estimating bid document addendum 03

project: Cobscook Bay State Park - Shower Building & Utility Improvements
Dennysville, Washington County, Maine BGS # 3473

date: 27 June 2024

SHEET C-102

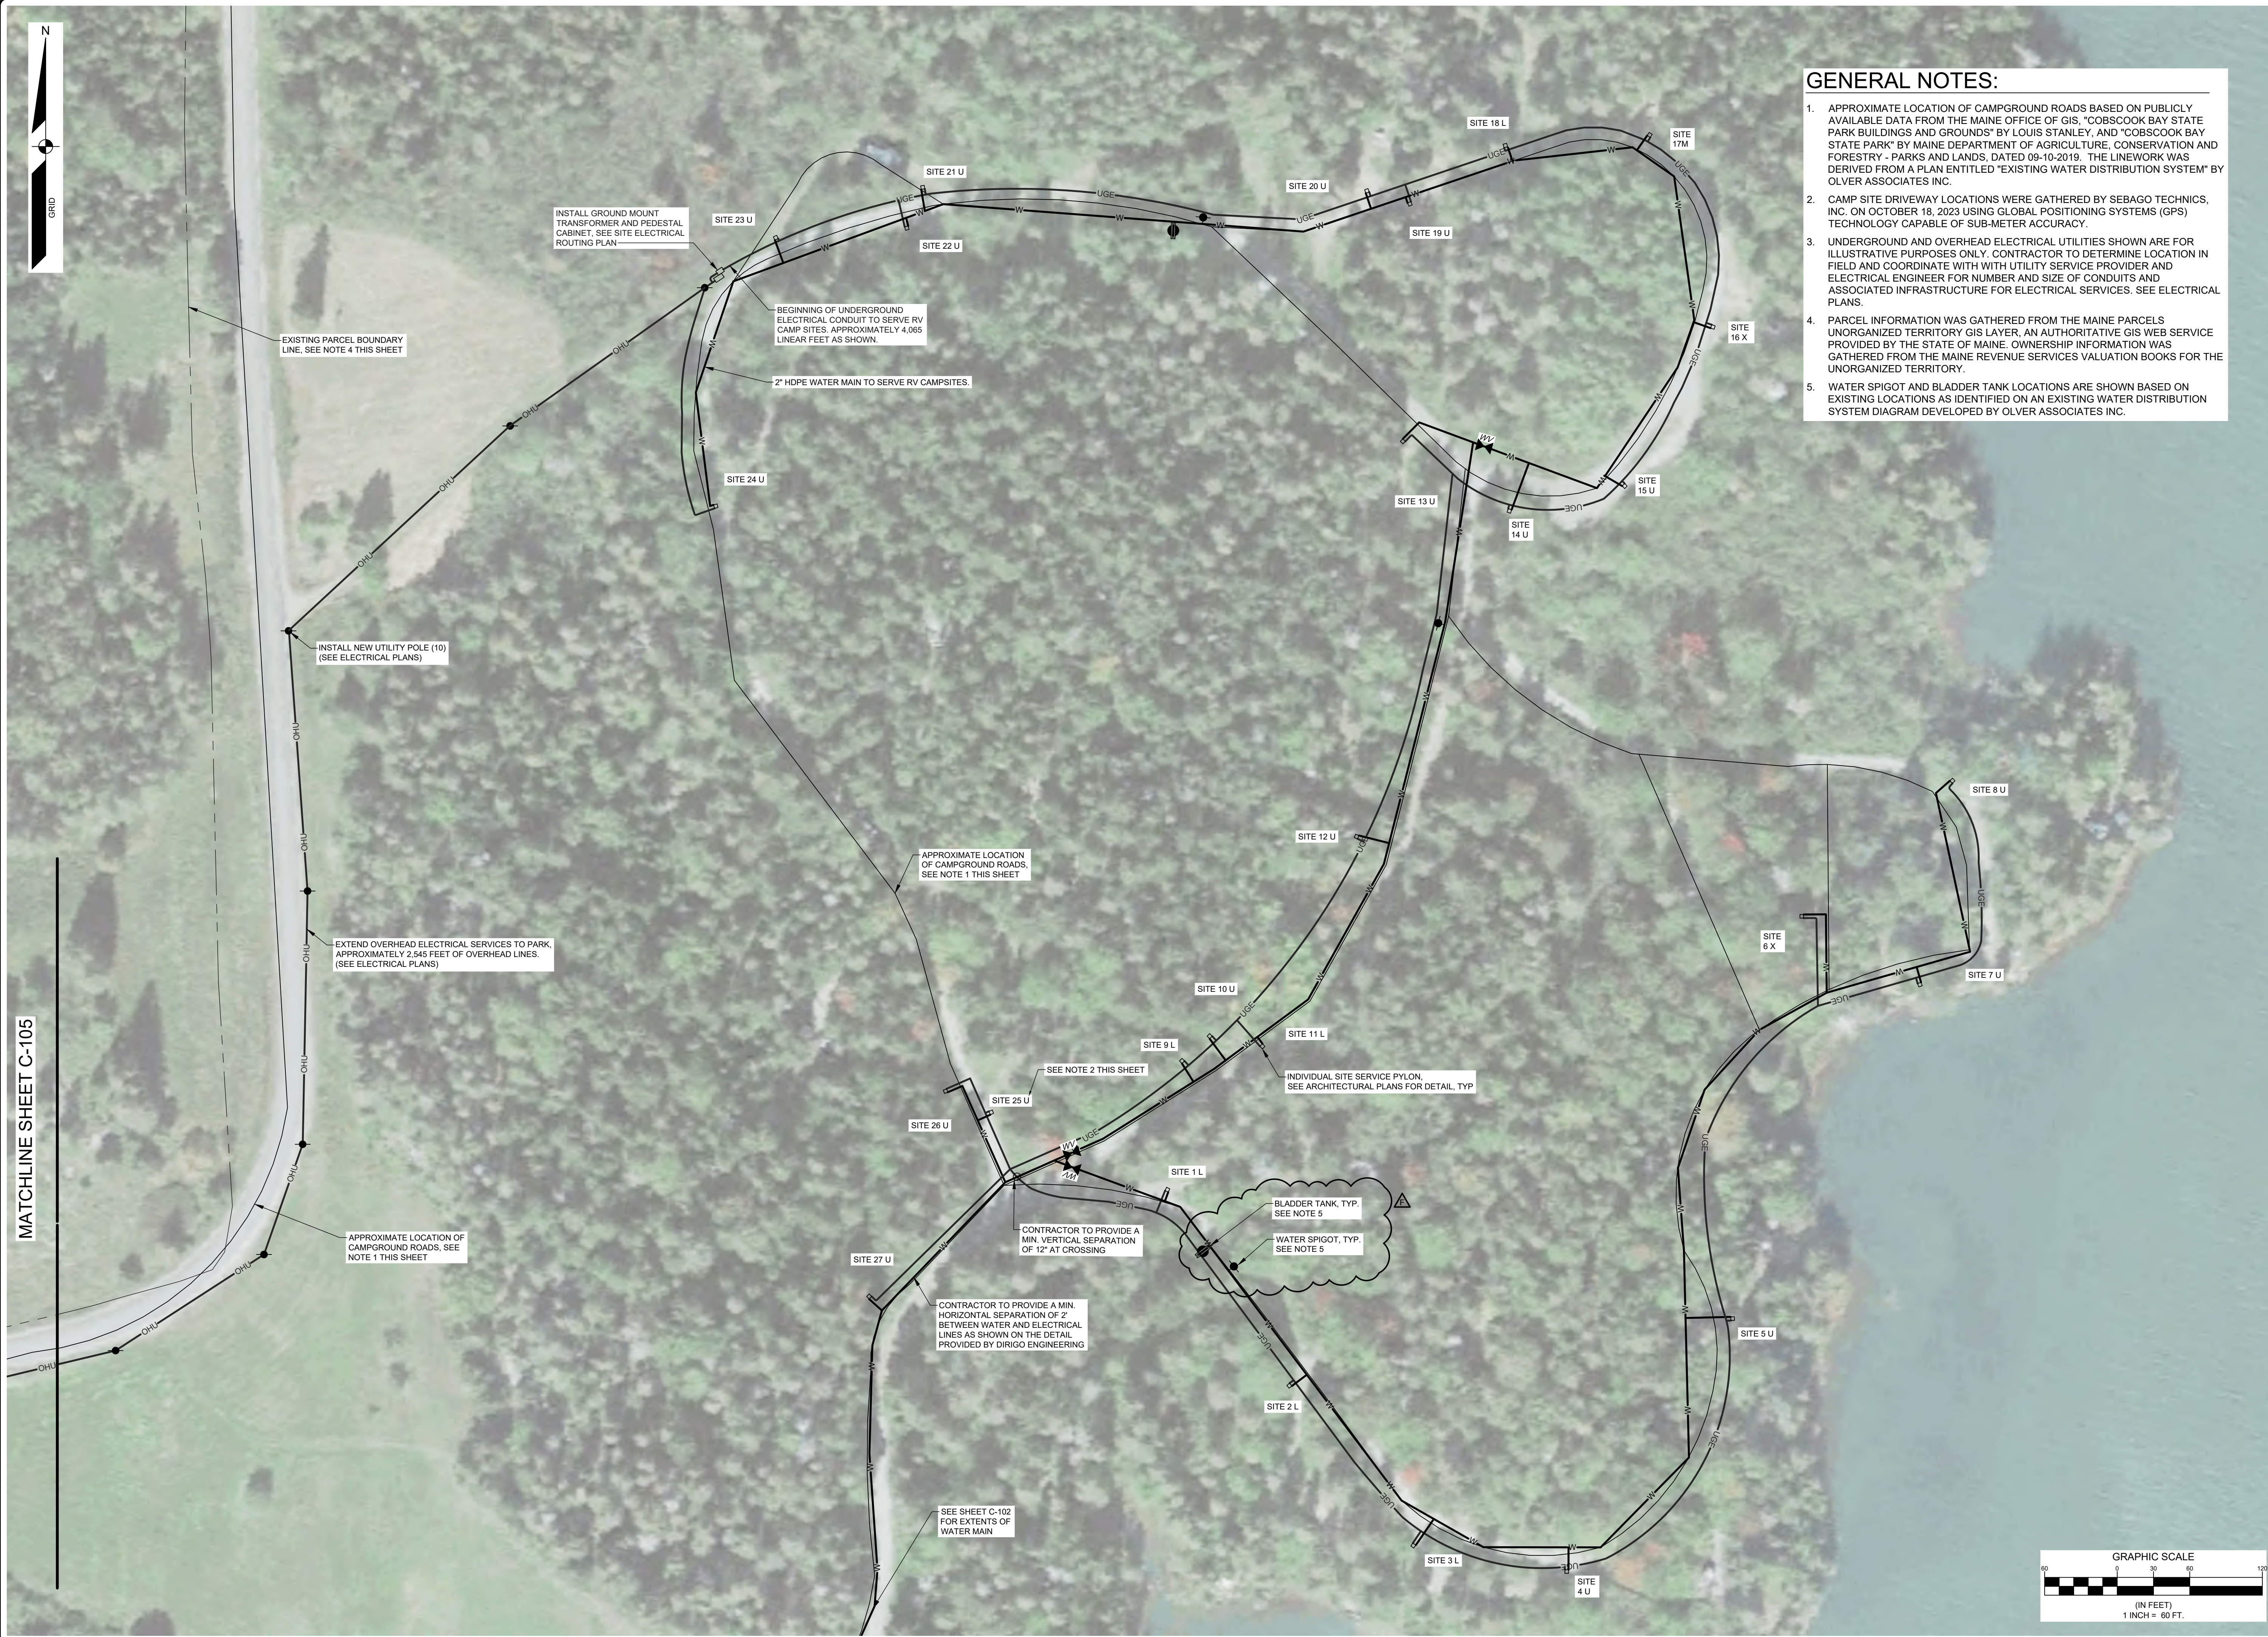
2. Replacement of existing park water system. Contractor to replace existing water pipe throughout the park as depicted on the updated C-102. Contractor is responsible for determining the precise length of piping and equipment necessary to improve the fall decommissioning of the system, spigot access, and improved pressure through looping. Trenches shall follow the existing pipe route unless improved locations are determined during replacement. Trench depths may be as shallow as 18 to 24 inches as long as the location is on the shoulder or center of the road. For additional information, see Olver Associates 2020 existing conditions and recommendations letter.
